**COLLIER COUNTY**  
**ADDENDUM No.6**  
**TO**  
**CONTRACT DOCUMENTS**  
**FOR**  
**BID #18-7305**  
**PROPOSED MASTER PUMP STATION 306.00**

WASTEWATER BASIN ANALYSIS-BASIN 306-MASTER PUMP STATION 306

**A12 | FUEL OIL PIPING SUPPORT**

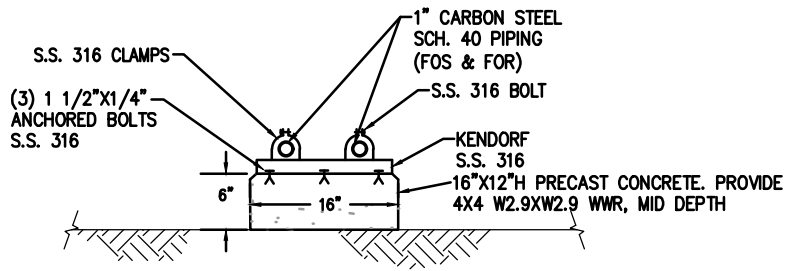
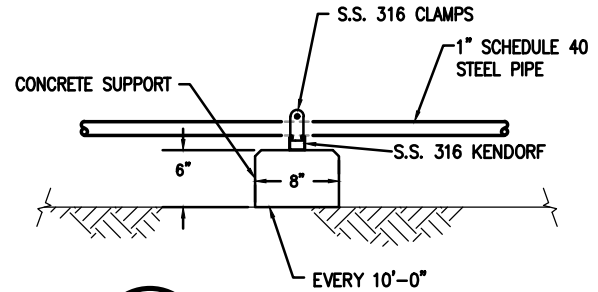
6. Drawing P-502 Plumbing Details II: Modify sheet by inserting "Fuel Piping Support Detail" as provided in Attachment 1 as detail A12.

NOTE: PROVIDE 3/4" CHAMFER ALONG ALL UPPER EDGES OF CONCRETE PIPE SUPPORT.
